## Application for Licence Amendment

<b>Licence Number</b>	L6465/1989/10
<b>Licence Holder</b>	Alcoa of Australia Limited
<b>ACN</b>	004 879 298
<b>File Number</b>	DWERVT15844
<b>Premises</b>	Willowdale Mine Part of Mineral Lease 1SA  Willowdale Rd (via Wagerup Refinery Access Rd) WAROONA WA 6215  As defined by the maps in Schedule 1
<b>Date of Report</b>	28 October 2024
<b>Decision</b>	Revised licence granted

Figure 4: Orion Sumps layout

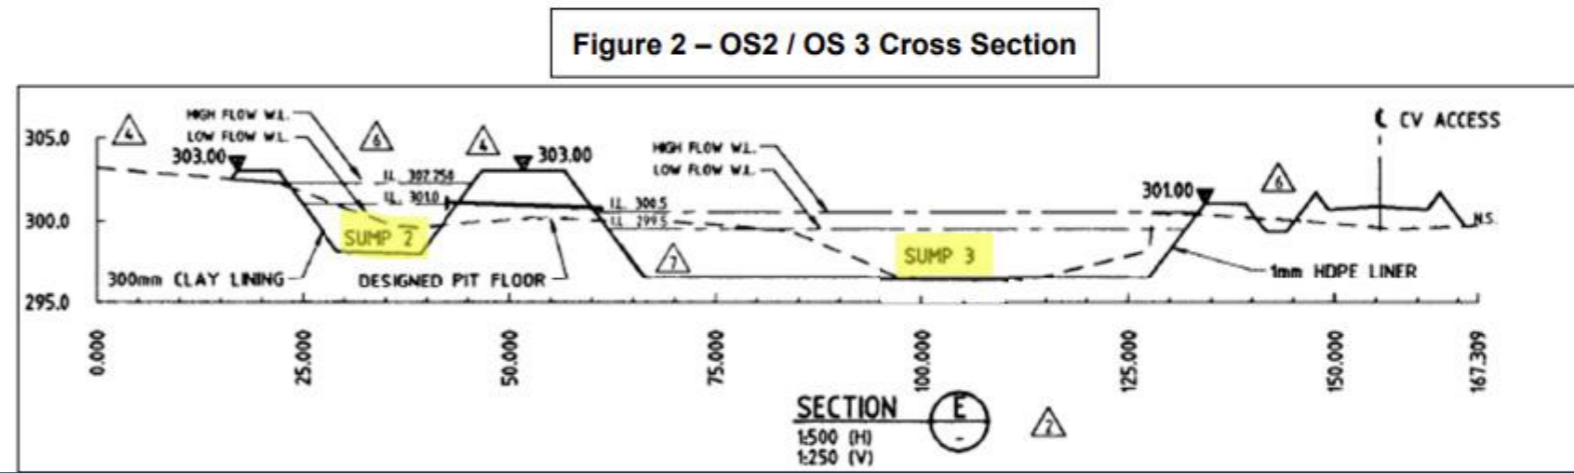
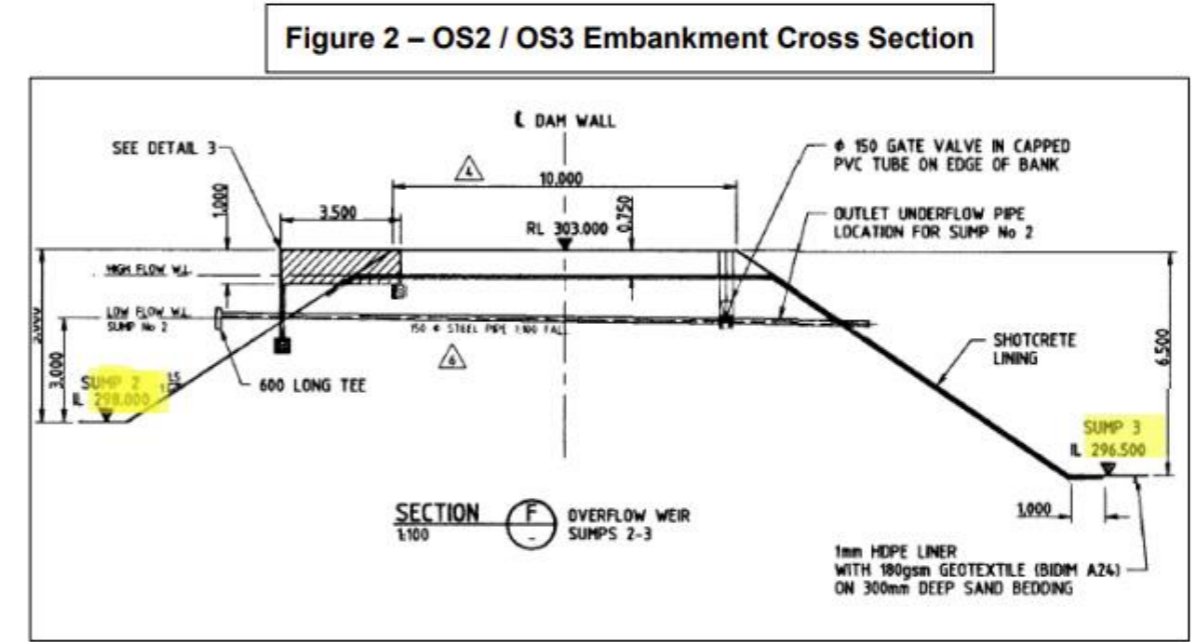
The licence holder has indicated that the sumps were and are designed to be operated in sequence where water overflow is transported via gravity through buried pipelines from OS1 to OS2 to OS3 (Figure ). The OS1 to OS2 overflow pipeline connection comprises of five 83.6 m underground pipelines each with a diameter of 600 mm. The OS2 to OS3 overflow pipeline connection involves a separate pipeline for operation during low flow conditions and another two pipelines for high flow conditions. Maintaining the 30% freeboard within OS1 and OS2 results in the ponds not being able to function properly as designed as it prevents water levels within the ponds reaching the overflow pipes. A summary of the pipelines is presented in Table 2 and the layout and cross sections are presented in Figure .
